Interstate 15/Railroad Canyon Road Interchange Improvement Project

CITY OF LAKE ELSINORE
RIVERSIDE COUNTY, CALIFORNIA
DISTRICT 08 – RIV – 15 PM 18.3/21.0
EA 08-0A4400 PN 080000016

Initial Study with Mitigated Negative Declaration/ Environmental Assessment with Finding of No Significant Impact

August 2017

FIGURE 1.4
Sheet 2 of 4

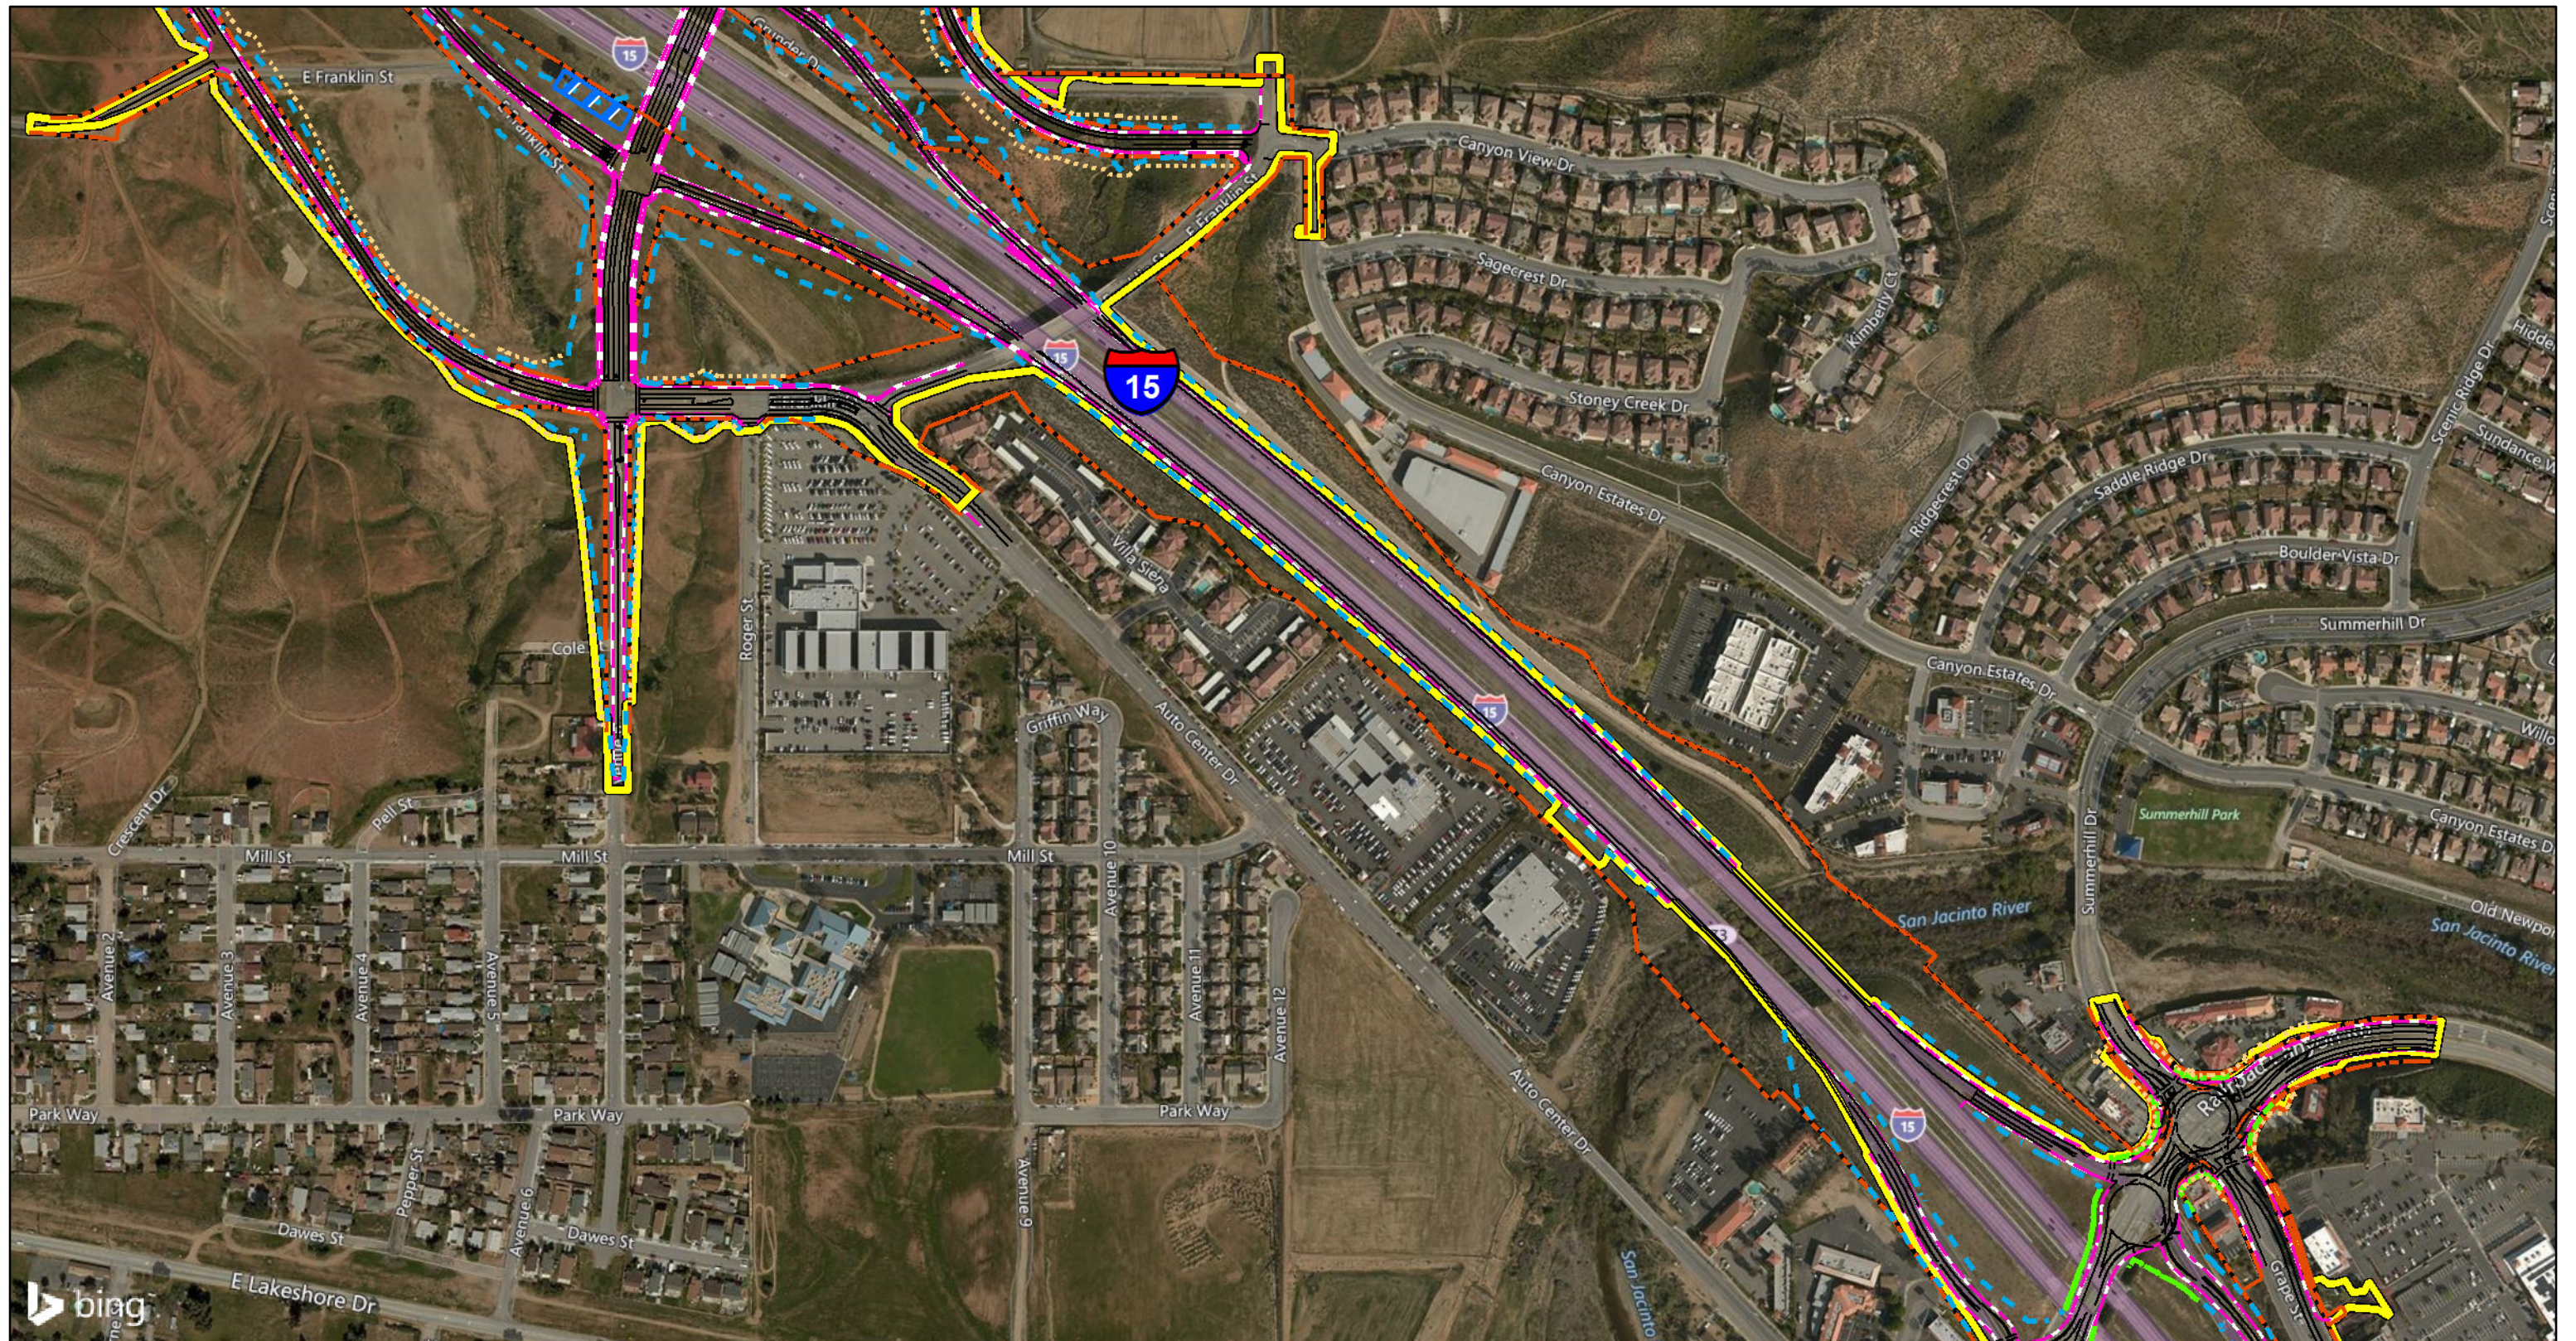
- Is it anticipated that this portion of the frontage road will fill and traverse the gully at ground level, or is a bridge anticipated here?
4. Figure 1.4, Sheet 2 of 4

- The orange lines with black dots is Alt 4 - Proposed Right of Way, is that correct?
 - If I am reading this correctly, this right of way indicates on Sheet 2 of 4 that Bancroft will intersection and merge into the Western Frontage road immediately prior to Ave 6, that Avenue 5 will intersect the

- Is the circulation scheme in this area as depicted in Figure 1.4 Sheet 2 for Alternative 4 different than the circulation schemes for Alternatives 2 and 3?
- If not, why is no similar ROW designation show for Alternative 2 on Figure 1.2 sheet 2 of 4 or Alternative 3 on Figure 1.3, sheet 2 of 4?
- Why is no cut and fill shown in this area for Alternative 4, when the cut/fill legend was provided for Alternatives 2 and 3?
- After accounting for the cut and fill required to construct the Franklin/I-15 Interchange, is the ROW envisioned for Bancroft, Avenue 5, and Franklin in the second question above (Section 4, bullet point 2) still viable?

H-3	Based on the conceptual design for this frontage road at the time of the analysis, the depression/gully would be filled with fill material to construct the road at grade. No bridge structure would be included with the construction of the frontage road.
H-4	Correct. The orange and black lines on Figure 1.4 represent the Proposed Right-of-Way for Alternative 4.
H-5	No. Some of the orange and black lines depicted in Figure 1.4 of the Draft IS/EA were included inadvertently and do not represent the Proposed Right-of-Way for Alternative 4 accurately. The planned improvements on sheet 2 of 4 in Figure 1.4 are identical for all Build Alternatives. Therefore, sheet 2 of 4 in Figures 1.2 and 1.3 are representative of the planned improvements that should be depicted in Figure 1.4. As a result, Figure 1.4 has been corrected to remove unnecessary lines and be consistent with the information depicted in Figures 1.2 and 1.3.

Comment	Response
H-6	The circulation scheme for the area in the vicinity of the Franklin Street interchange area, as depicted in Figure 1.4 sheet 2, is identical for Alternatives 2, 3, and 4. There is no difference in the circulation scheme between the three Build Alternatives at this location. Some of the orange and black lines depicted in Figure 1.4 of the Draft IS/EA were included inadvertently and do not represent the Proposed Right-of-Way for Alternative 4 accurately. The planned improvements on sheet 2 of 4 in Figure 1.4 are identical for all Build Alternatives. Therefore, sheet 2 of 4 in Figures 1.2 and 1.3 are representative of the planned improvements that should be depicted in Figure 1.4. As a result, Figure 1.4 has been corrected to remove unnecessary lines and be consistent with the information depicted in Figures 1.2 and 1.3.
	Cut-and-fill data were inadvertently left out of Figure 1.4 in the Draft IS/EA. Figure 1.4 has been corrected to include information relating to cut and fill for Alternative 4 in this Final IS/EA.
